Certificate of Appropriateness

101 E. KILBOURN AV.

PTS ID 37285 COA, rebuild, restore Kilbourn bridge over the Milwaukee river

CERTIFICATE OF APPROPRIATEMENTS APPLICATION FORM ATTACHMENT A
KILBOURN AVENUE BASCULE BRIDGE
Kilbourn Avenue at the Milwaukee River

NO.	DATE	REVISION	BY
STATE OF WISCONSIN DEPARTMENT OF TRANSPORTATION STRUCTURES DESIGN SECTION			
STRUCTURE P-40-881			
CONSTR. SPEC.	2004	DRAWN BY WJ	PLANS CKD. GK/BT
STONE RAILING REPAIR			SHEET A14 OF A27
(1 OF 4)

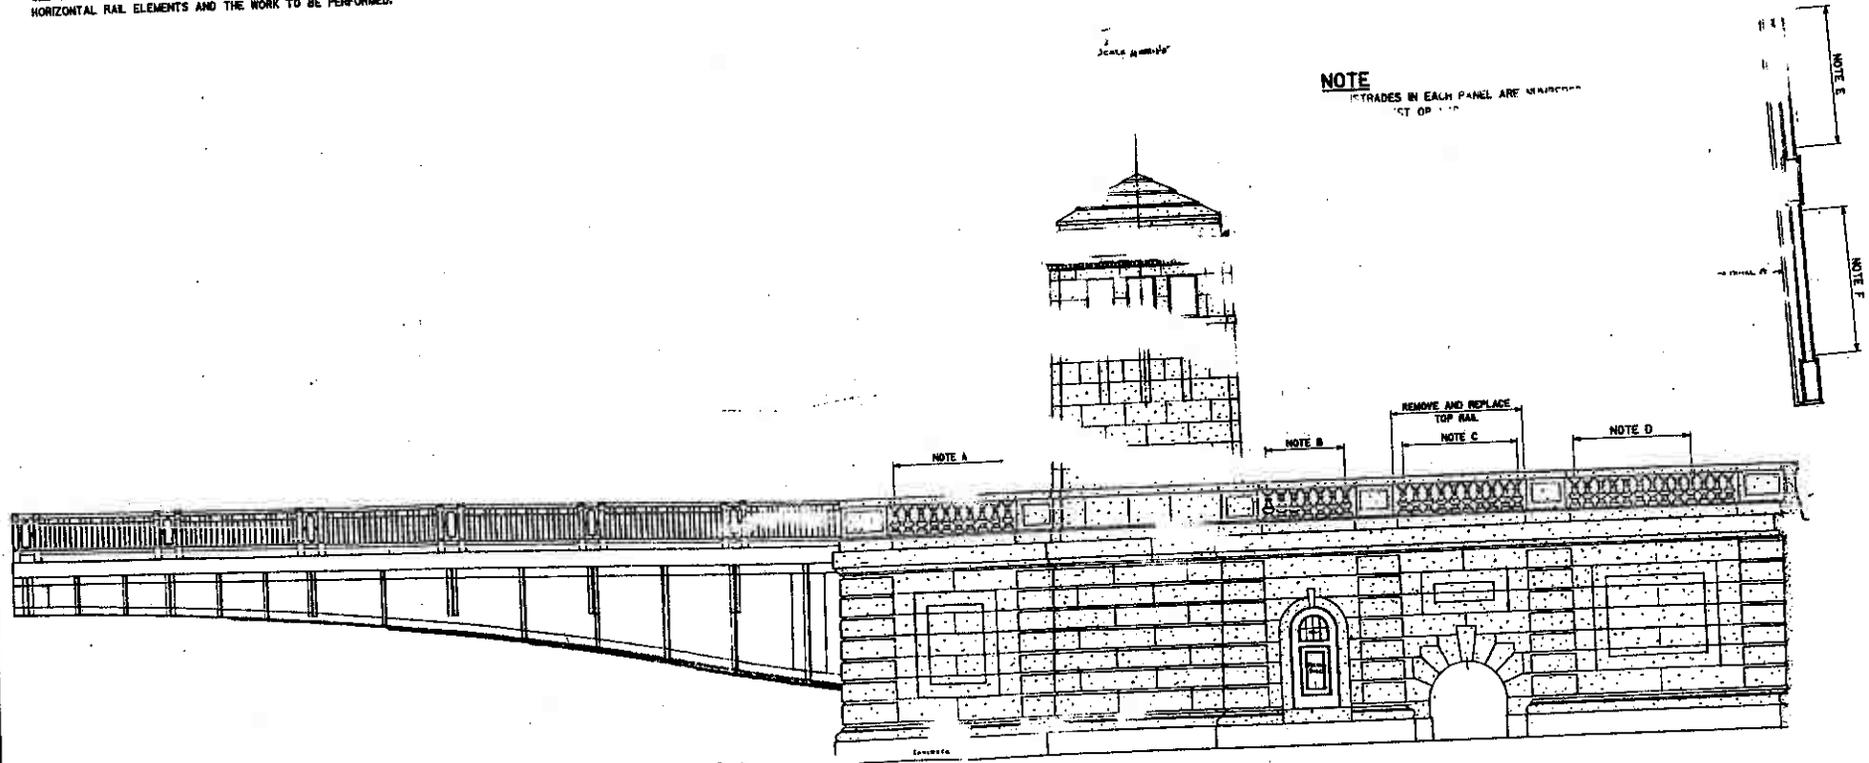
Care should be taken to replace any damaged stone on the bridge houses with matching new stone that is carefully finished to the specifications of the original stones. Most of the stones are called "ashlars" and are characterized by a subtle grooving of their surfaces, which elegantly catches the light and cast small shadows on the face of the stone. Replacement of the stone balusters should be held to a minimum.
